# SPECIFICATION FOR SET OF METALLIC PLATES FOR WAG-9 (Co-Co), ELECTRIC LOCOMOTIVES

## SPECIFICATION No. CLW/ES/3/0450 ALT. ~~I~~ J
## ISSUE DATE: 07.02.2000

## ALTERATION RECORD SHEET

CLW/ES/3/SK-2/0450

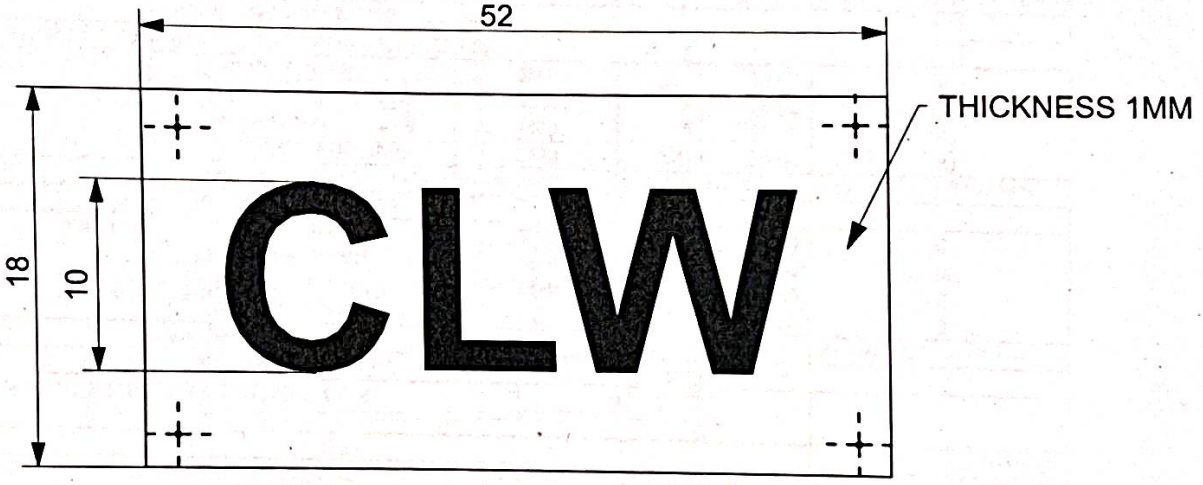
| ALT. No. | DATE | REASON | AUTHORITY |
|---|---|---|---|
| J | | Para 4 modified. Drawing of Metallic plate Aluminium plate modified to specify Grades for IS 6651 & IS 1868. | |

MATERIAL: AL ANODISED OXIDISED AS PER ~~IS:1868 & IS:6651~~ *
BACKGROUND: BLANK
SCRIPT: BLACK.

* IS 6651-1972 Gr-19000 (1C) & IS 1868:1996 Gr-AC10

CLW/ES/3/SK-4/0450

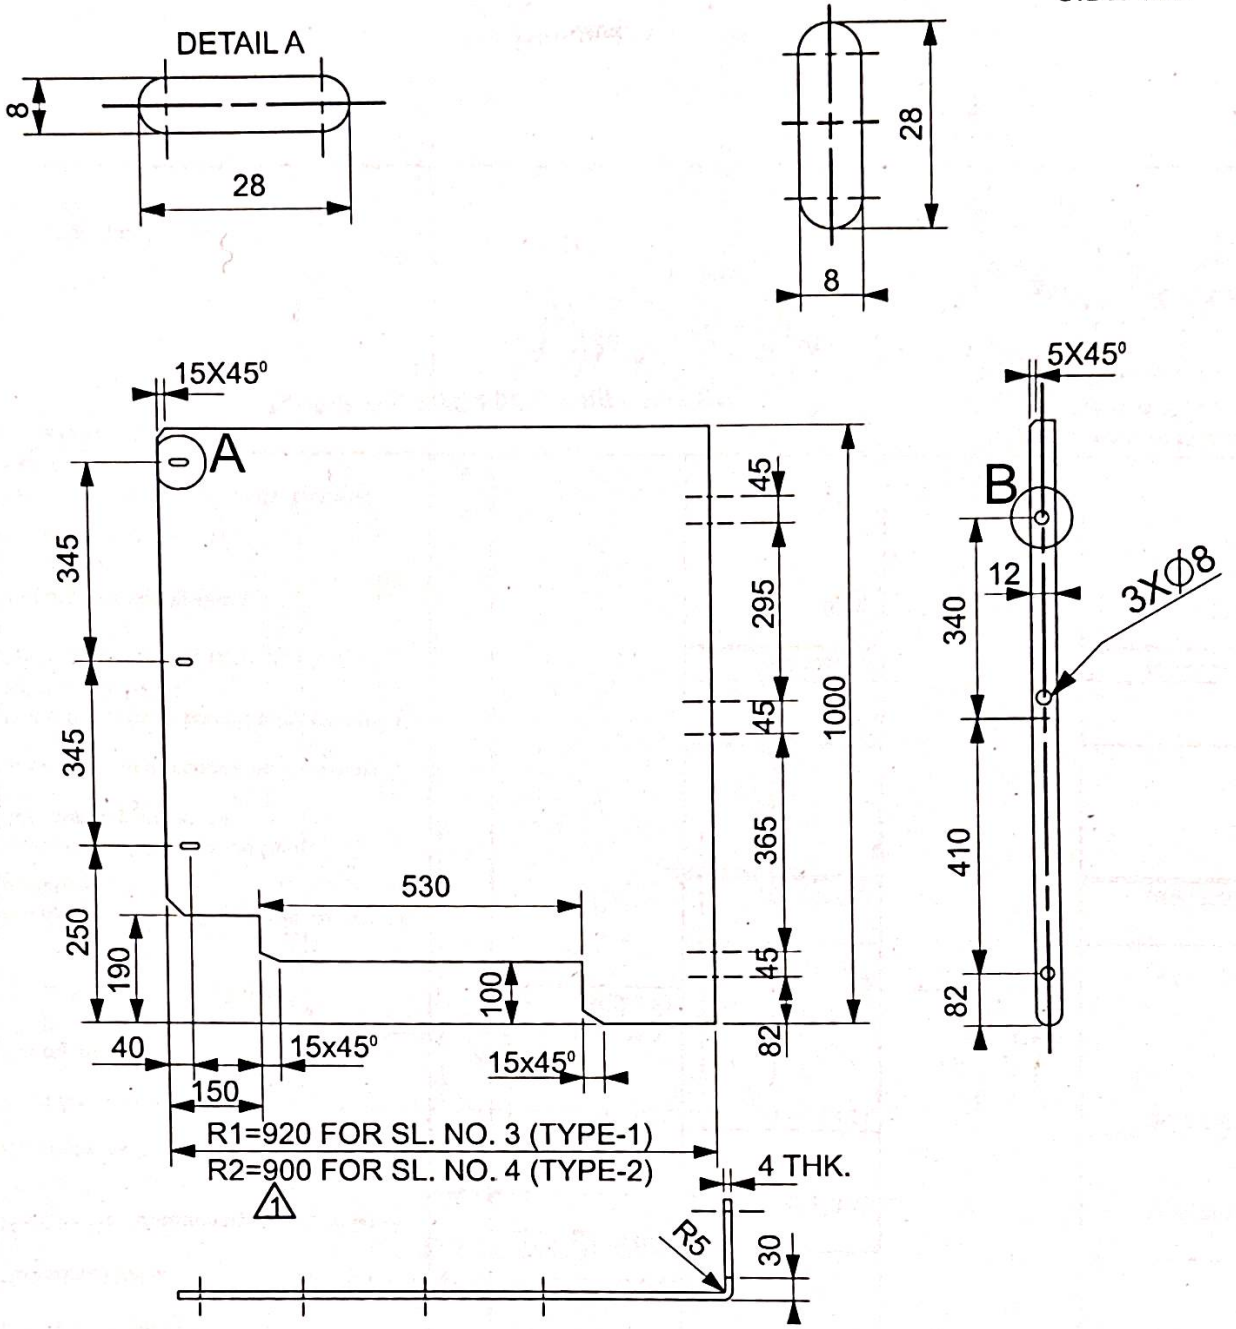
| ALT. No. | DATE | REASON | AUTHORITY |
|---|---|---|---|
| F | 10.05.2021 | Design of angle plate Type 1 & Type -2 is modified at Sketch no. CLW/ES/3/SK-4/0450 | S/d-<br>10.05.2021 |
| H | 18.01.2025 | Para 4 & 5 are corrected.<br>Drawing No. SK-4, SK-5, SK-6, SK-9, SK-13 & SK-16 are corrected.<br>Drawing No. SK-11 is modified. | S/d-<br>18.01.2025 |

MATERIAL: ALUMINIUM ANODISED OXIDISED AS PER ~~IS:1868~~ *IS 1868:1996 Gr. AC-10 & ~~IS:6651 DEG.~~ **19000(IC)

| 1 | DYCEE/O-4 | DIMENSION CORRECTED FOR R2 AND SL. NO. ALSO CORRECTED FOR R1 AND R2 | |

CLW/ES/3/SK-6/0450

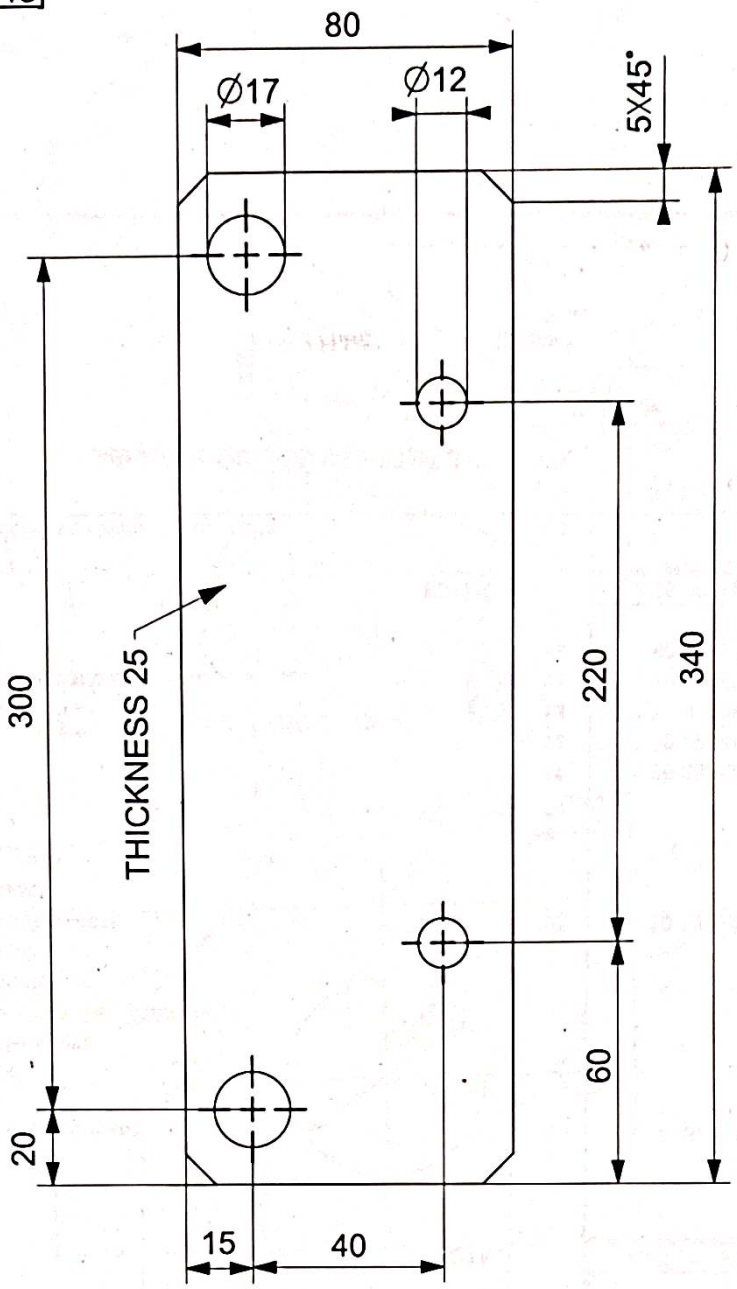
MATERIAL:-ALUMINIUM ANODISED OXIDISED
AS PER ~~IS:1868.& IS:6651~~*

| परिवर्तन संख्या ALT.NO | प्राधिकार AUTHY | वर्णन DESCRIPTION | दिनांकित आद्यक्षर DATED INITIAL |
|---|---|---|---|
| 1 | Dy CEE/D-III | SL. NO. DELETED | |

* IS 6651-1972 Gr-19000 (1C) & IS 1868:1996 Gr-AC10

CLW/ES/3/SK-13/0450

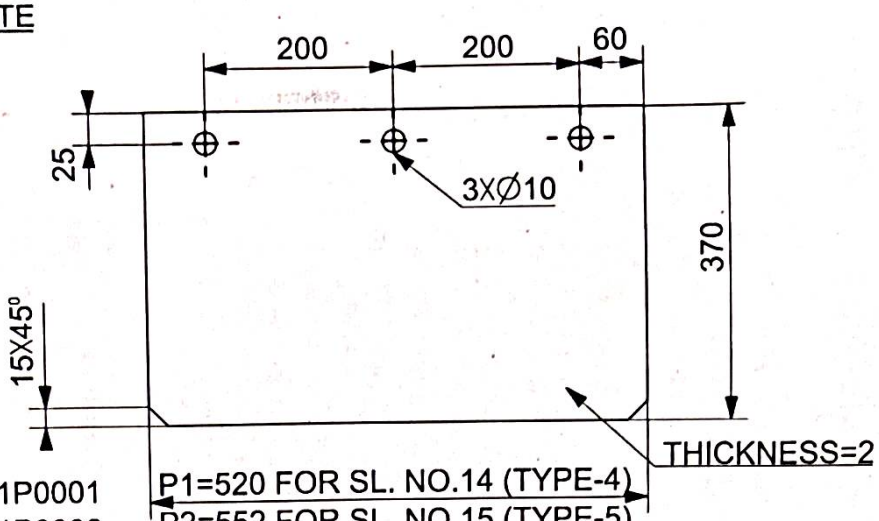
P1=520 FOR SL. NO.14 (TYPE-4)
P2=552 FOR SL. NO.15 (TYPE-5)
△1

| 1. | Dy CEE D-II | IN SK-13 SL. NO CORRECTED FOR P1&P2 DIMN CORRECTED FOR P2 SK-5 SL NO CORRECTED | | | | | | | | | | | |

IDENT NO. 3EHP431722P0001
CLW/ES/3/SK-5/0450

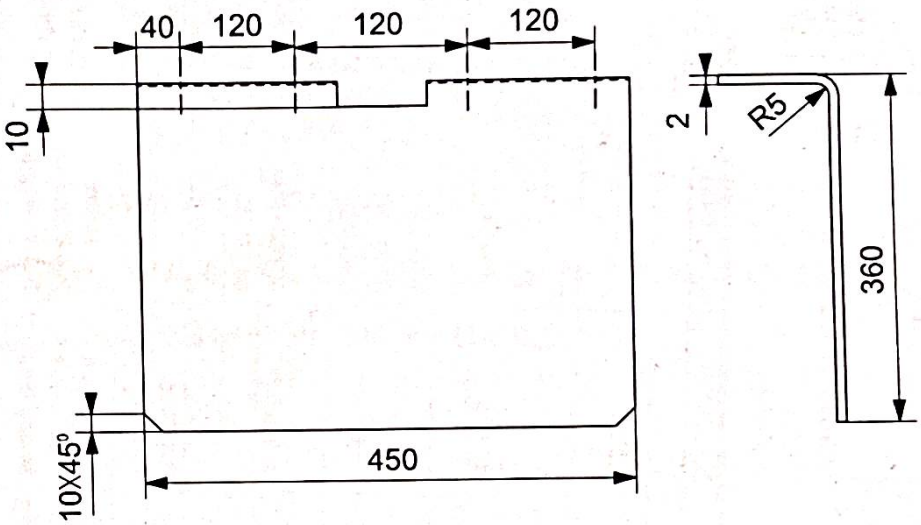
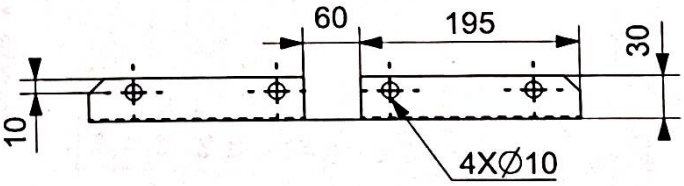
MATERIAL:-ALUMINIUM
ANODISED
OXIDISED AS
PER ~~IS:1868 &~~
~~IS:6651~~ *

* IS 6651-1972 Gr-19000(1C) & IS 1868:1996 Gr-AC10
